# 17-125ARB-MSP – LIBRARY AND PARKING GARAGE SIGNS

A Master Sign Plan (MSP) for permanent signs for the library and the parking garage, and signs for the temporary construction fence.

A proposal for a Master Sign Plan for the Columbus Metropolitan Library, Dublin Branch and Downtown Dublin Parking Garage.

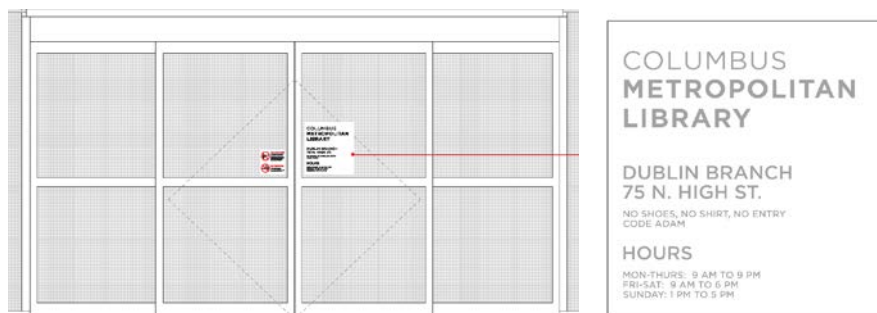
The proposal includes one ground sign for the library, located in the landscape area along North High Street. Code permits an eight-square-foot ground sign, six feet in height and located eight feet from the right-of-way. The proposed sign is 16 square feet in area and 6.5 feet tall. The sign is an internally-illuminated, metal sign cabinet, incorporating the Columbus Metropolitan Library colors and logo.

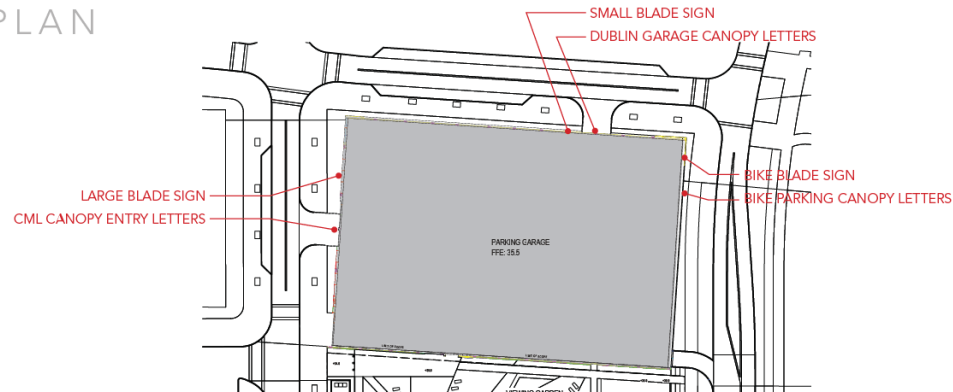
The North Street (south) elevation includes a 151-square-foot projecting sign and a 23-square-foot canopy sign. The proposed projecting sign includes a metal sign cabinet with open face, illuminated, channel letters for the "PARK" text and the standard parking symbol mounted on a silver background; and silver, pin mounted letters on a black background for the "Dublin Parking Garage" text. The projecting sign is located along the North Street elevation, west of the vehicular entrance. The proposed projecting sign is similar in design to the proposed parking garage signs in the Bridge Park development.

The proposed canopy edge sign include orange, internally-illuminated, channel letters for the "Library Parking" text. The canopy sign located above the vehicular entrance canopy along North Street.

The proposed sign plan indicates additional graphics located within the interior of the garage at the North Street entrance. Planning understands these graphics may change over time and recommends an additional sign type be added to the Master Sign Plan to allow for these internal graphics visible from the public right-of-way.

- 1) That the applicant reduce the height of the proposed stairway numbers to six feet in height.
- 2) That the applicant include an additional sign type to allow the internal wall graphics at the North Street entrance.

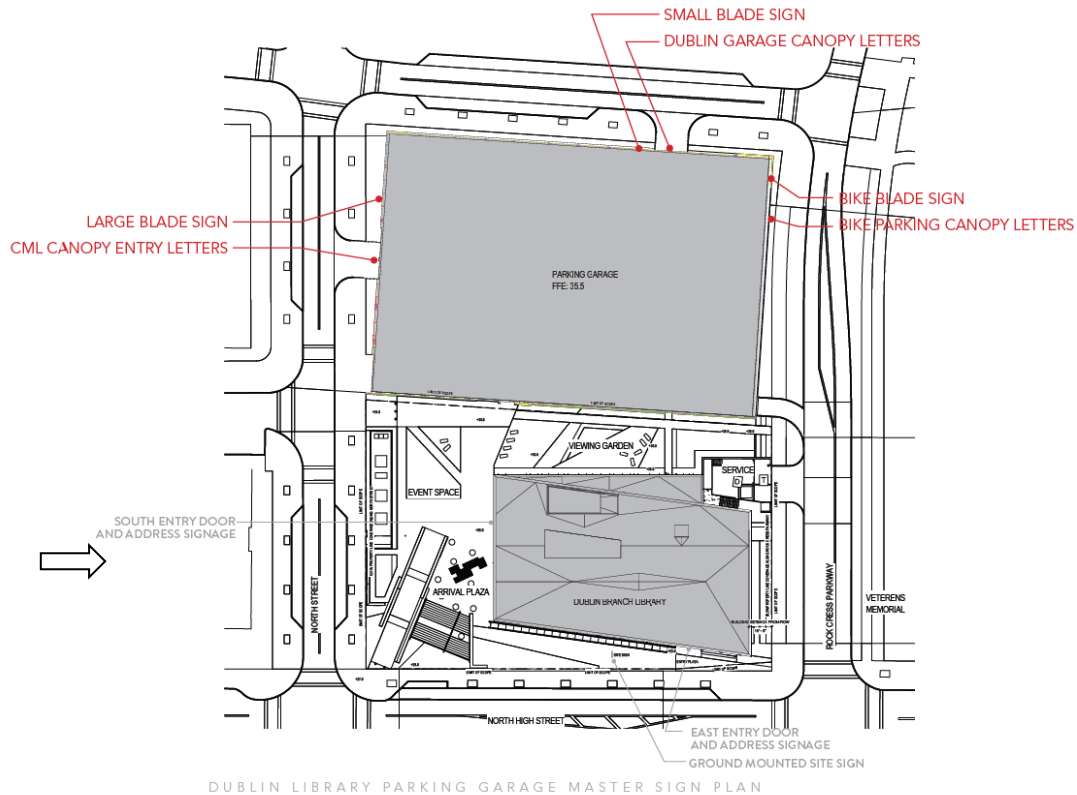
Code permits one, 32-square-foot temporary development sign per street frontage, up to two signs. The proposal includes two, 96-square-foot signs located along North Street and North High Street on the existing construction fence.
